# **Central Planning Authority**

**Agenda** for a meeting of the Central Planning Authority to be held on **13 February 2024 at 10:00am** in Conference Room 1038, 1st Floor, Government Administration Building, 133 Elgin Avenue

**CPA/05/24**

*Figure 1. Protected areas in the vicinity of the after-the-fact Road (Source: DoE, 2023).*

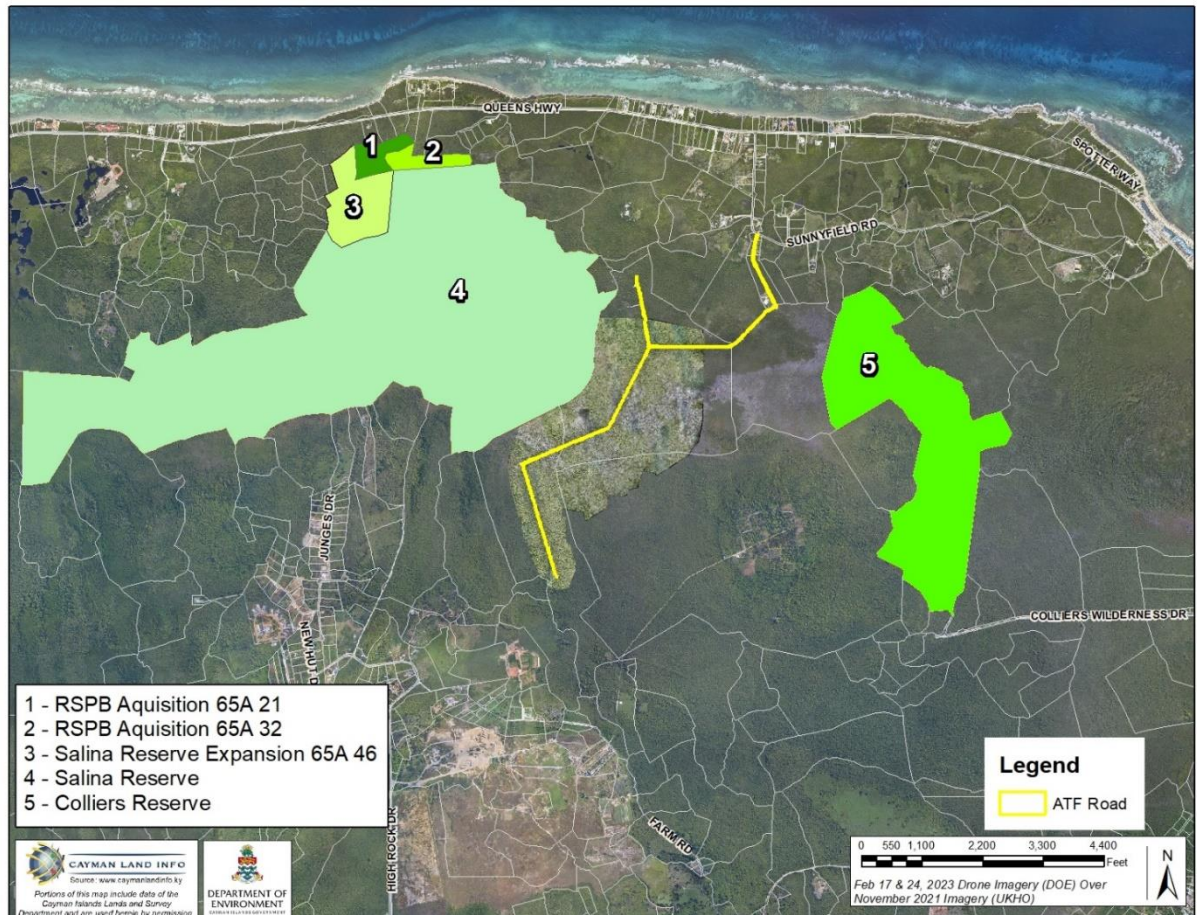
- *The nearby parcel, Block 65A Parcel 21, was purchased by the Royal Society for the Protection of Birds (RSPB) in 2019, as their first investment in land in a UK Overseas Territory, and is leased to the National Trust for their protection.*
- *The RSPB has purchased a second parcel, Block 65A Parcel 32, as a second investment contiguous with the Salina Reserve with the land transfer still in progress.*
- *In 2022, the government purchased Block 65A Parcel 46 for protection under the National Conservation Act as part of a further expansion of the Salina Reserve.*

- *The Salina Reserve is an internationally recognised Important Bird Area by Birdlife International.*
- *The Salina Reserve and Colliers Wilderness Reserve are the main release sites for captive-bred Blue Iguanas, which has been funded by millions of dollars of donations from individuals, organisations and corporate sponsors over time.*

*The level of investment by the Crown, by the National Trust of the Cayman Islands, by RSPB and by the public all indicate just how important this area is for preservation and conservation.*

*Figure 3. The road width as indicated on the surveyor drawing (red) is much smaller than the as-built road width (blue) for which the applicant is seeking after-the-fact permission (Source: DoE, 2023).*

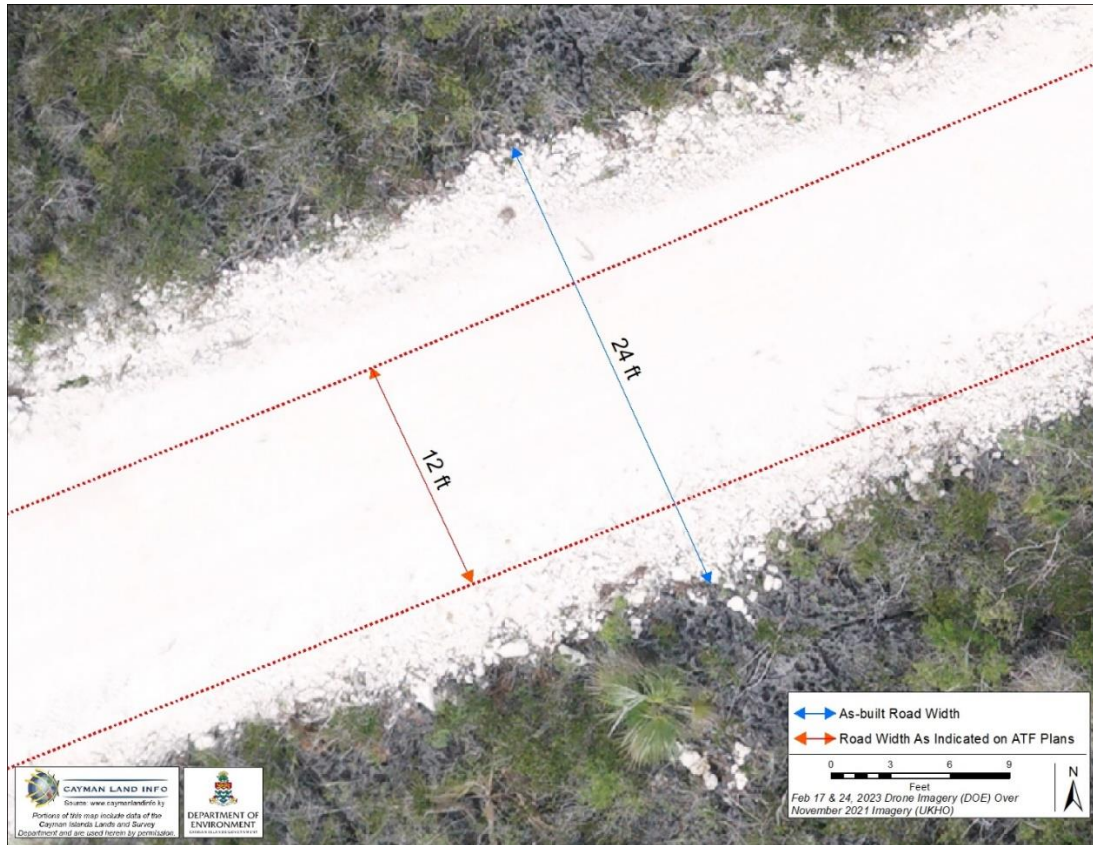
- 5. The application letter from Greg Abernethy also states, "Due to the rough construction of the road, vehicles will only be able to travel at low speeds (15 MPH or slower)." The road is constructed of well-compacted fill and it is certainly possible to travel at speeds greater than 15 MPH on this road as there are no hindrances and it is long and straight. Evidence of speeds sufficiently high to kill wildlife are shown in Figure 5.*

*Figure 2. The survey drawing of the extent of the after-the-fact road is shown as red. However, the width of the road is wider than depicted (see the areas of white fill exposed on either side of the red dashed line) and the area impacted by clearing (blue) is even larger based on our drone imagery (Source: DoE, 2023).*

*Figure 6. Landcover map showing the habitat at the site (Source: DoE Landcover, 2013). The road primarily proceeded through areas of mangrove forest and areas of sparsely vegetated rock – both unsuitable for agriculture.*

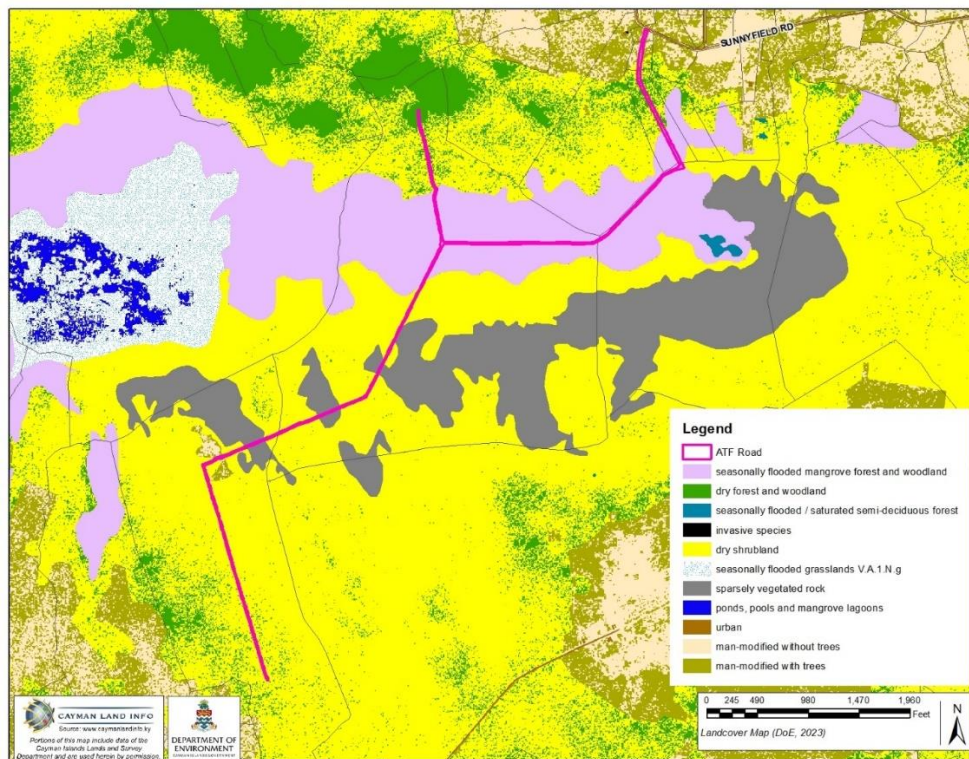
- *The vast majority of the site is unsuitable for agriculture, and it does not seem logical to construct such a major road through areas of mangrove forest and rocky karst landscape for ‘agricultural purposes’ when these areas do not have the conditions suitable for agriculture (see Figure 6 and 7).*

*Figures 1-2. Sea turtle tracks show that the turtle crawled up the beach until it reached a construction site (Source: DoE and Tammy Kelderman, 2021). The fence in Figure 1 is dangerous to sea turtles as it is sharp, rusty, and not secure.*

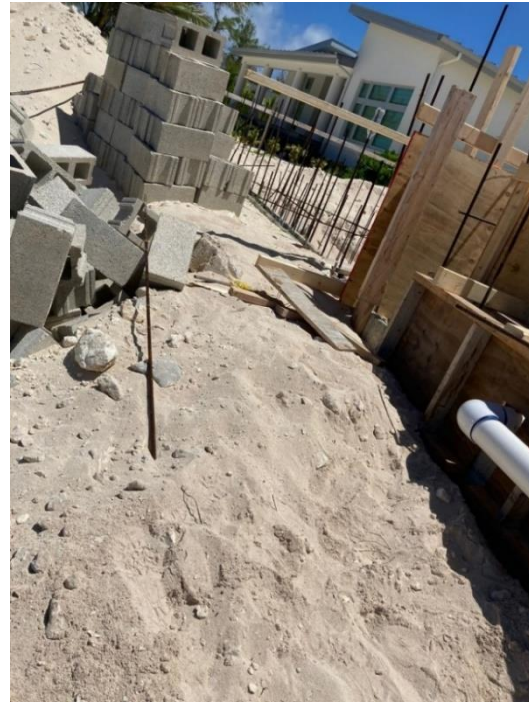
*Nesting sea turtles often use vegetation as a cue for nesting, and will crawl landwards up the beach until they reach the vegetation, or on a modified beach, a hard structure. When the vegetation is removed for construction, sea turtles can enter construction sites and be*

harmed. Figures 1 to 4 show sea turtle tracks directly up to construction sites. The DoE has also been called to respond numerous times to sea turtles who have become trapped in construction sites. Figure 5 shows a sea turtle hatchling which was killed due to heavy equipment being operated on the beach.

*Figure 1: Extract of the application site outlined in red showing the elevations within the parcel based on Lands and Survey 2018 digital terrain model. (Source: Cayman Land Info)*

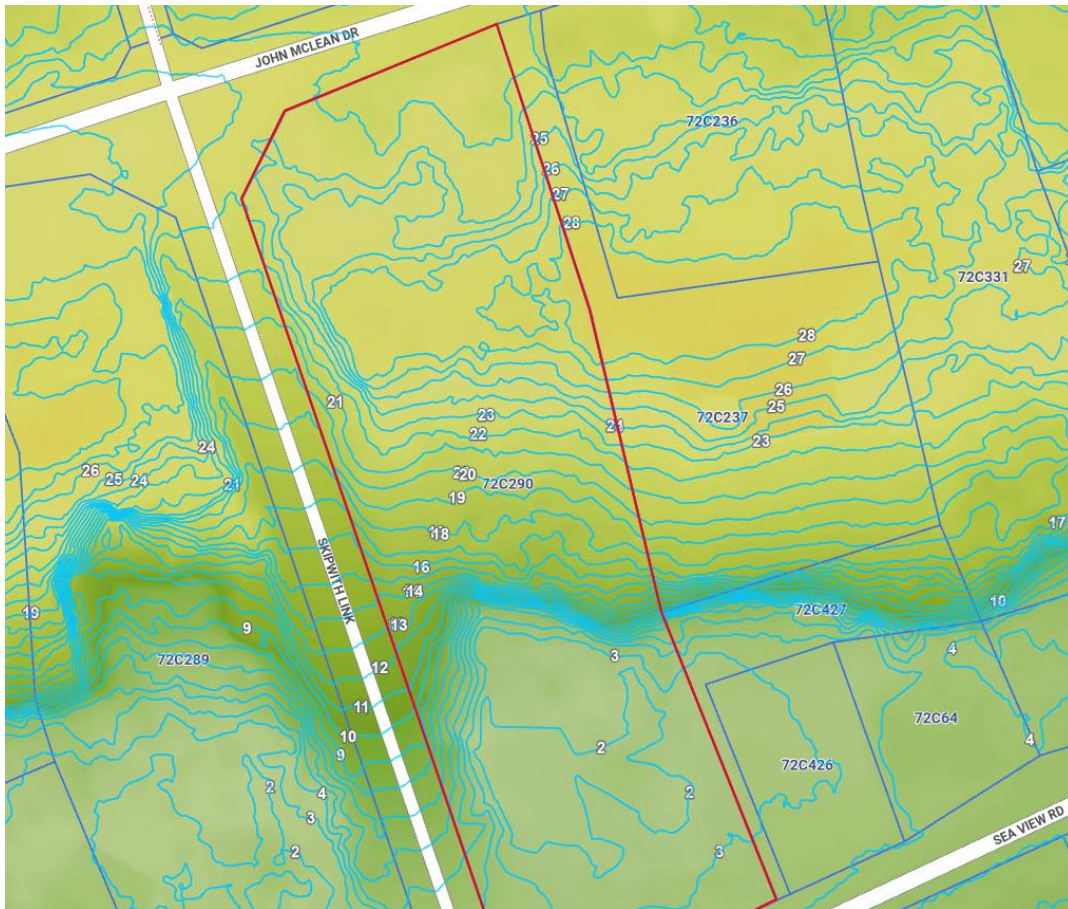
*We note that the parcel contains an elevated ridge as shown in Figure 1. Based on the site plans submitted, it appears that the applicant will be retaining the elevation. We are encouraged to see that the applicant will retain the ridge. We support this retention and would not support the excavation of the ridge.*

Figure 2. The location of the subject parcel (outlined in blue) within the limits of the Historic Overlay Zone (Aerial Imagery Source: UKHO, 2021).

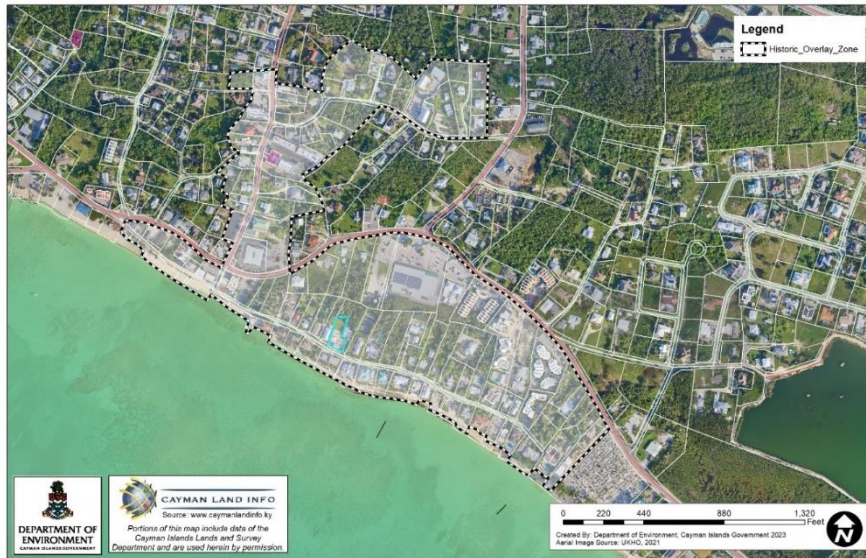
*The subject parcel is man-modified, with an established traditional Caymanian house on the property. The subject parcel is also located across Boggy Sands Road from designated Critical Habitat under the Interim Directive for the designation of Critical Habitat of Green turtles (*Chelonia mydas*), Loggerhead turtles (*Caretta caretta*), Hawksbill turtles (*Eretmochelys imbricata*), Leatherback turtles (*Dermochelys coriacea*) and all other species that may occur in Cayman waters including Kemp's Ridley turtles (*Lepidochelys kempii*) and hybrids (2020) issued under section 17 (7) of the National Conservation Act (2013) (refer to Figure 1).*

*There is a traditional Caymanian house already located on the parcel, which the planning application drawings make no reference to. This property house is listed on the National Trust for the Cayman Islands' Heritage Register under WB 003-01 as Herbert Parson's House. It was constructed using ironwood stilts, shiplap timber and a zinc roof. The date of construction is not known although it appears to long pre-date any available aerial imagery for the area.*

*There is no reference to this existing house on the planning submission drawings, but it is clear from the application drawings that the existing buildings are incompatible with the proposed development and that it would be required to be demolished to accommodate the proposed duplex. The proposed development has no characteristics that would be in keeping with the established historical, architectural or cultural character of the area (refer to Figure 3). Heritage is finite, and to demolish this historic house for construction of the proposed duplex would be in direct contradiction to the intent and aims of the Historic Overlay Zone. The importance of protecting heritage assets was also reflected in the draft National Planning Framework, 2018.*

*Figure 1. Proposed development site with the parcel boundary highlighted in red (Aerial Imagery Source: UKHO, 2021).*

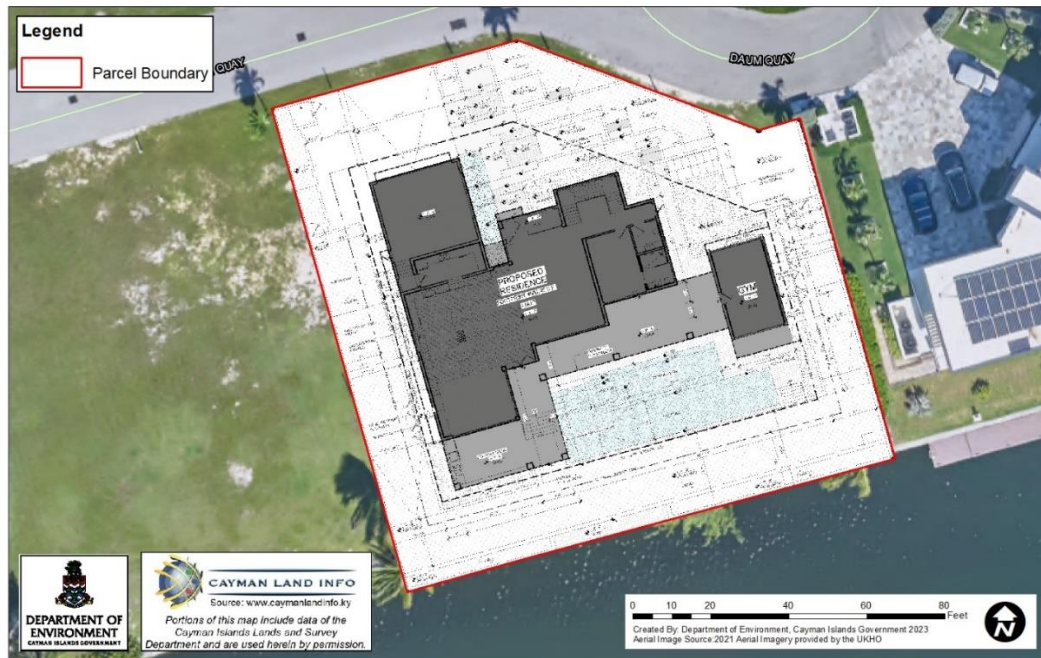
*The application site is man-modified and of limited ecological value (Figure 1). We recommend that native plants are incorporated into the landscaping scheme. Native plants are best suited for the conditions of the site, including the temperature and amount of rainfall. They are climate-appropriate and require less maintenance and irrigation. Landscaping with native vegetation also provides ecological benefits by creating habitat and food for native fauna such as birds and butterflies, promoting biodiversity and providing valuable ecosystem services.*
